UNITED STATES PATENT AND TRADEMARK OFFICE

APPLICATION NO.	FILING DATE	FIRST NAMED INVENTOR	ATTORNEY DOCKET NO.	CONFIRMATION NO.
10/715,288	11/17/2003	Gareth G. Hougham	YOR920030496US1	7006

Office Action Summary

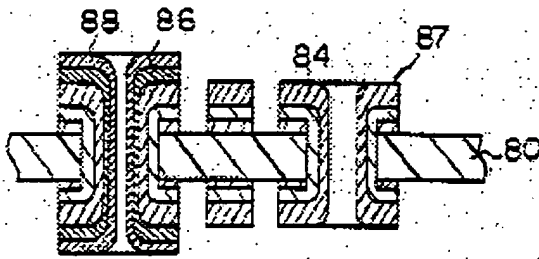
In regard to claim 1, Anselmo et al. disclose an interposer 11 comprising an electrically insulating carrier 11, an electrically conductive via 13 disposed in the carrier 11 and an electrical connector 20 that comprises a hollow body 23-26 of electrically conductive material that is disposed in electrical contact with the via 13 on opposite sides of the carrier 11 and that

has a plurality of surface voids (not marked, aria 25, 23 at the top and 31, 23 at the button, see Figs. 2 – 3) so that the electrical connector 20 accommodates forced physical and electrical contact with at least one separate electrical contact (see Abstract, lines 4-5).

Attachment 1

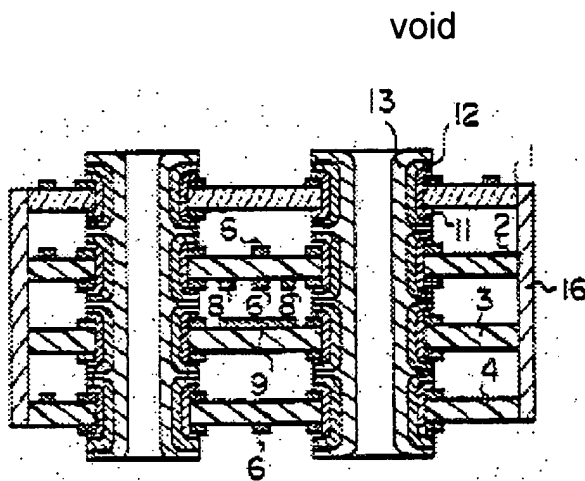
In regard to claim 1, Kurosawa et al. disclose an interposer (not marked, see Attachment 1) comprising an electrically insulating carrier 80, an electrically conductive via 10 (Fig.1C) disposed in the carrier 80 and an electrical connector 84, 87 that comprises a hollow body (not marked) of electrically conductive material that is disposed in electrical contact with the via 10 on opposite sides of the carrier 80 (see Fig. 9D) and that has a plurality of surface voids V (see Attachment 1) so that the electrical connector 20 accommodates forced physical and electrical contact with at least one separate electrical contact.

In regard to claim 4, Kurosawa et al. disclose the hollow body 86, 88 comprises at least two voids V (see Attachment 1) in registration with one another and disposed on opposite sides of the carrier 80.

In regard to claim 5, Kurosawa et al. disclose the carrier 80 comprises a plurality of the electrically conductive vias V (see Attachment 1) each disposed in electrical contact with a different one of a plurality of the hollow bodies 86/88.

Attachment 2

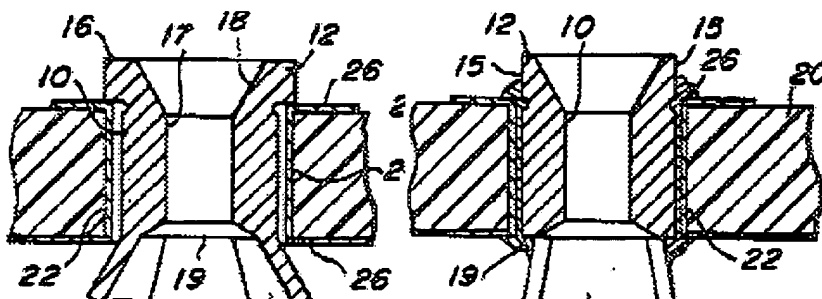
In regard to claim 1, DeSantis et al. disclose an interposer (not marked, see Attachment 2) comprising an electrically insulating carrier 20, an electrically conductive via 22 disposed in the carrier 20 and an electrical connector (socket) 12, 10, 14 that comprises a hollow body 10 of electrically conductive material that is disposed in electrical contact with the via 22 on opposite sides of the carrier 20 (see Figs. 3 - 4) and that has a plurality of surface voids 18 so that the electrical connector 12, 10, 14 accommodates forced physical and electrical contact with at least one separate electrical contact.

In regard to claim 4, DeSantis et al. disclose at least two of the surface voids 18 are in registration with one another and disposed on opposite sides of the carrier 20.

In regard to claim 5, DeSantis et al. disclose the carrier 20 comprises a plurality of the electrically conductive vias 22 each disposed in electrical contact with a different one of a plurality of the hollow bodies 10.

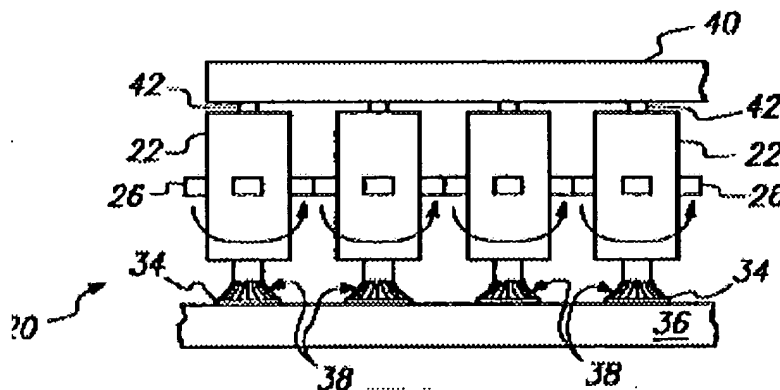
In regard to claim 41, DeSantis et al. disclose at least one of the voids is located to receive an optical signal so that the hollow body 10 is capable to accommodate both optical and electrical signals.

Attachment 4

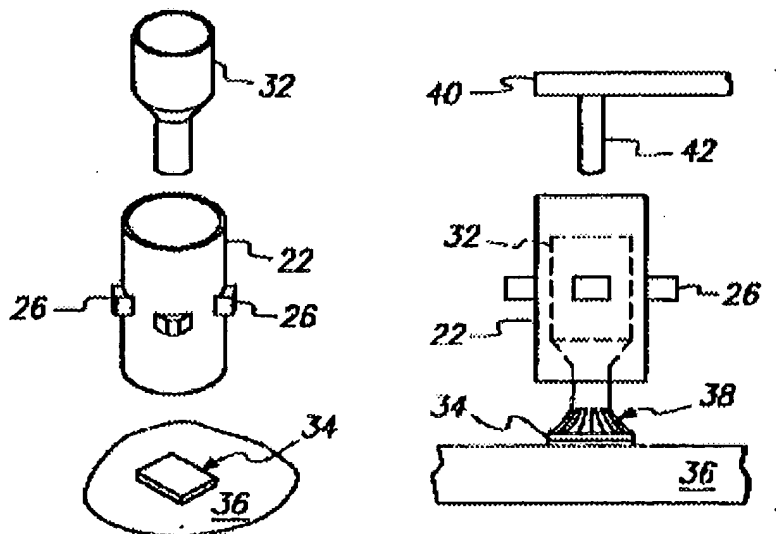
In regard to claim 6, Matsuba et al. disclose an interposer (not marked, see Attachment 4) for connecting a module 40 to a printing wiring board 36, comprising:

a carrier 20 that has at least one electrically conductive via (not marked, see Col.6, line 67 and Col.7, lines 1-3) and that is disposed so that the via is in registration with a connector 42 of the module 40 and a connector 34 of the printed wiring board 36, and at least one electrical contact button 32 that is hollow (see Fig. 4), that is disposed in the via (see Col.6, line 67 and Col.7, lines 1-3) for forced physical and electrical contact with the connector 42 of the module 40 and the connector 38 of the printed

wiring board 36 and that has at least one surface void V (not marked, see Attachment 4).
